CITY OF ALBUQUERQUE

PLANNING DEPARTMENT – Development Review Services

**Re: Garcias Kitchen Food Prep & Catering
Grading and Drainage Plan
Engineer's Stamp Date: 9-8-14 (J13/D096)**

RE: Re-submittal of Grading and Drainage Plan for Garcia's Kitchen Food Prep & Catering J13/D096

GRADING AND DRAINAGE PLAN

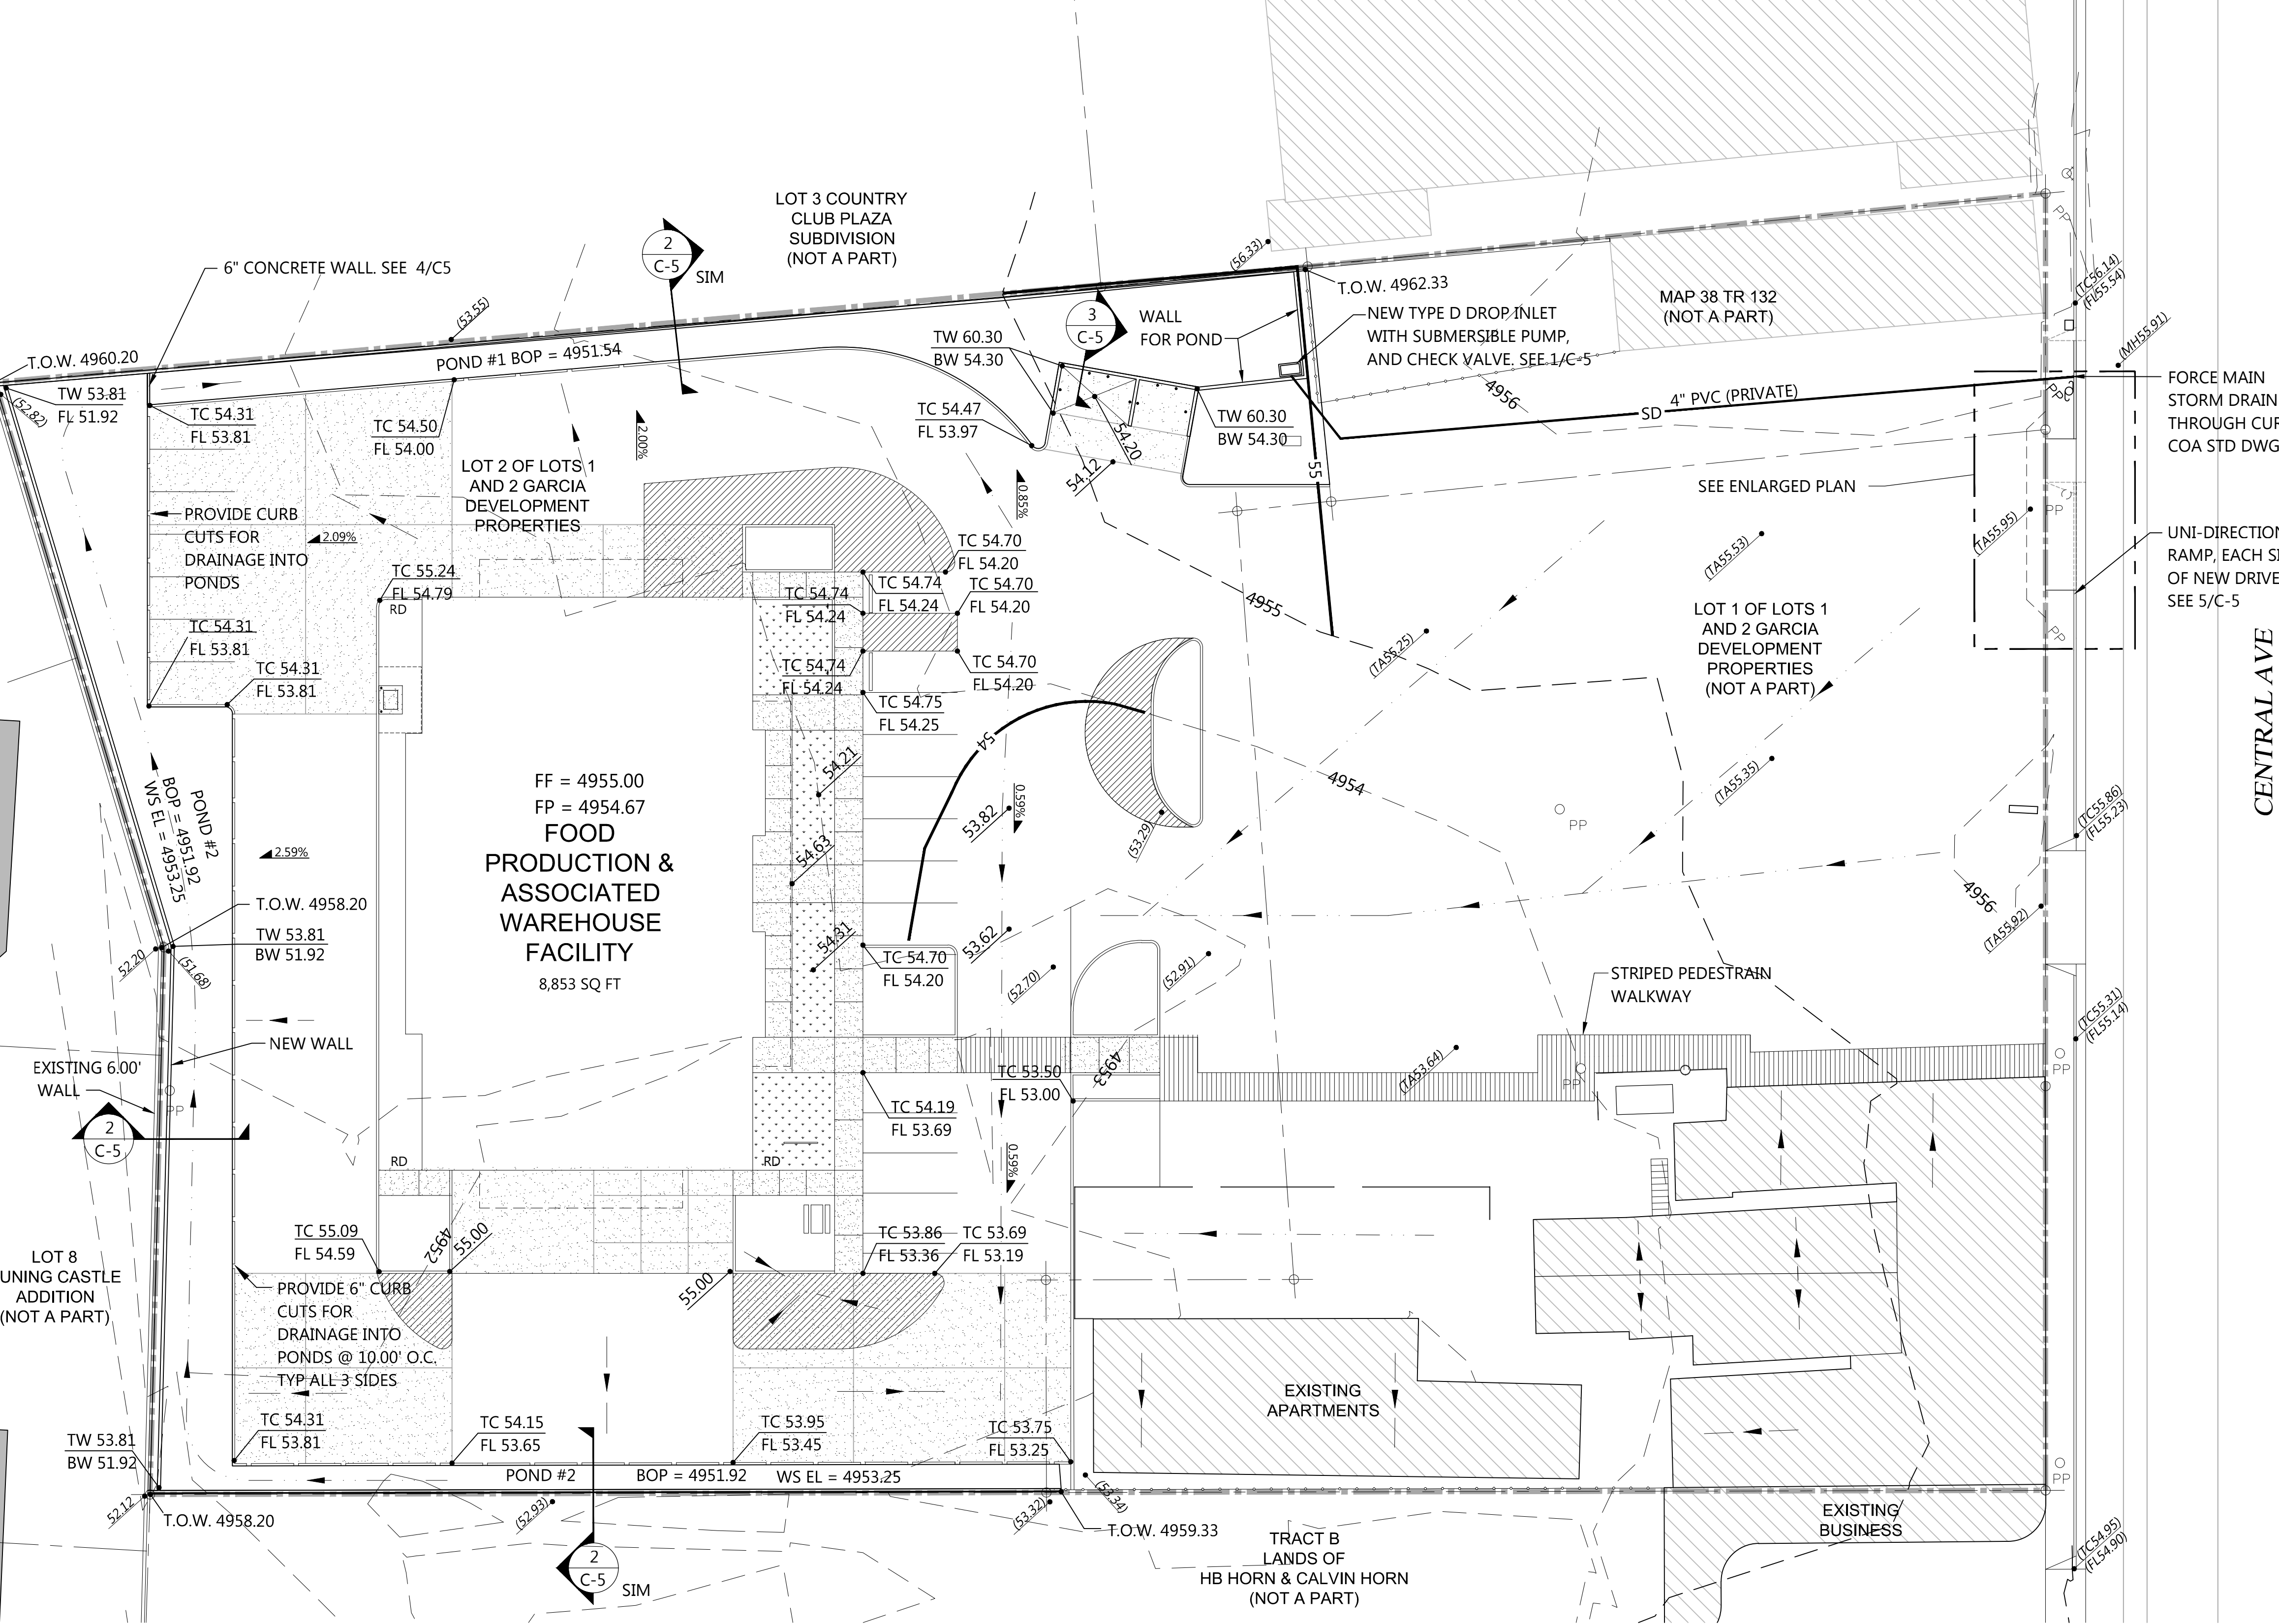
2. Onsite flows from the existing restaurant and apartments must be accounted for. The proposed curb south of these existing structures does not allow roof runoff from these structures to drain to pond 2. The flows have been accounted for in the calculations; a swale has been added east of the apartments to assure the runoff goes into pond 2. In addition a curb cut has been added to allow for drainage to enter pond 2.

3. Roof runoff from the apartments appears to drain offsite to east and then reenter the property and drain to the south west, along with some amount of offsite flows. LIDAR contours support this and so this onsite/offsite flows need to be accounted for. In addition, it appears that a wall is to be built along west property boundary. How will flows from apartments reenter? Some of the runoff from the apartments goes offsite historically. This plan does not plan to modify this condition except to collect the runoff from the east side of the apartments into a swale and direct to the pond. Off site grading is not proposed.

4. Sections thru pond on East and West property boundaries need to be shown to indicate how flows will reenter, or how overflows will be contained on site. Sections have been added to plans. The overflow from the pond will be contained within the parking lot of the property. The ponds have been design to contain the 100yr 24 hr flow which is in excess of city requirements.

5. It appears that Pond #2 volume should be the total volume of both ponds #2 and #3 from the previous submittal. With a combined larger volume the WSEL will be lower. Not correct. The WSEL Elevation calculated for the previous submittal took into consideration the total volume of Ponds 2 and 3. The previous submittal missed the volume of pond #2 when the two were combined that has been corrected.

PERFORMANCE CURVE

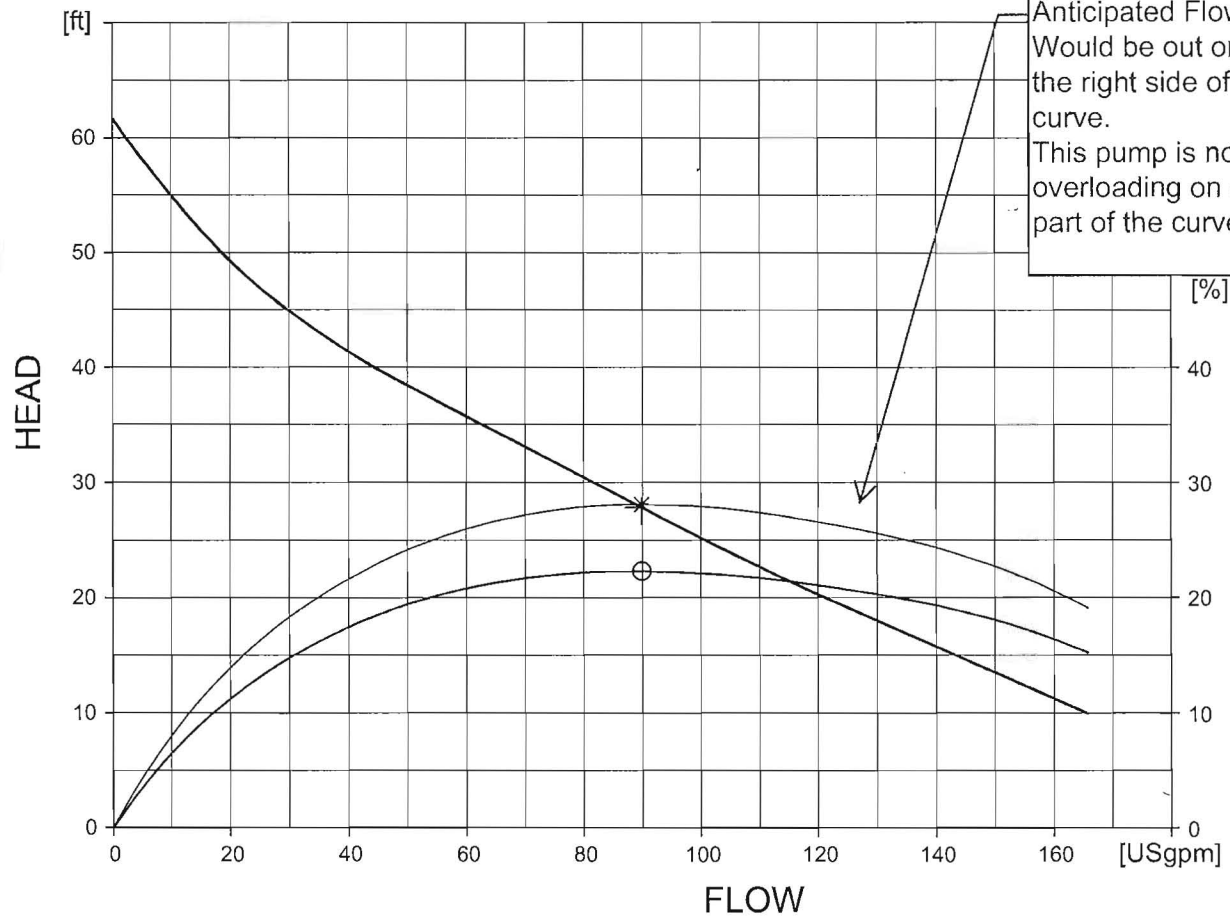
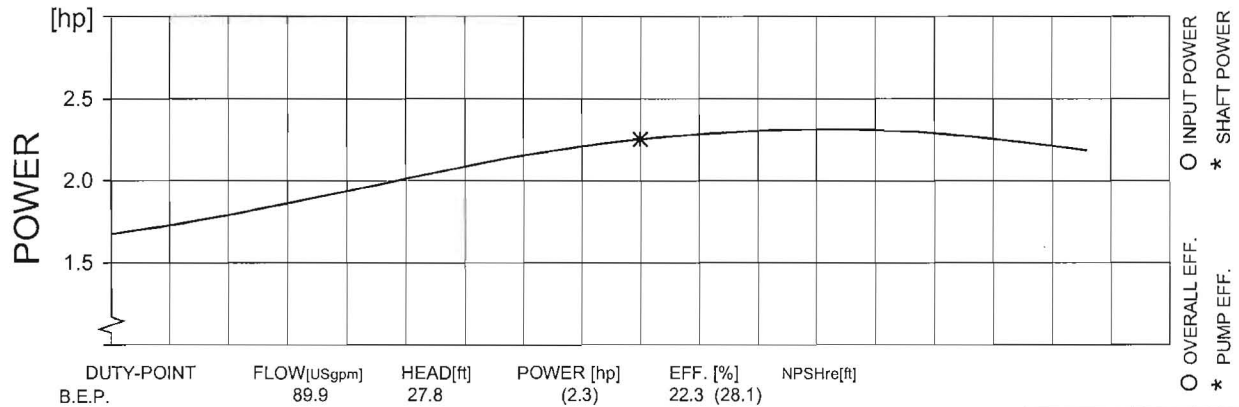
8. Pump Cut sheets provided show general information but do not show where on the curve the pump will operate (which is typically shown on a system curve), nor are there supporting calculations. Please provide. Attached to this letter is the pump cut sheets with the system curve identifying where the pump is designed to operate.

Anticipated Flow
Would be out on
the right side of the
curve.
This pump is non-
overloading on any
part of the curve.
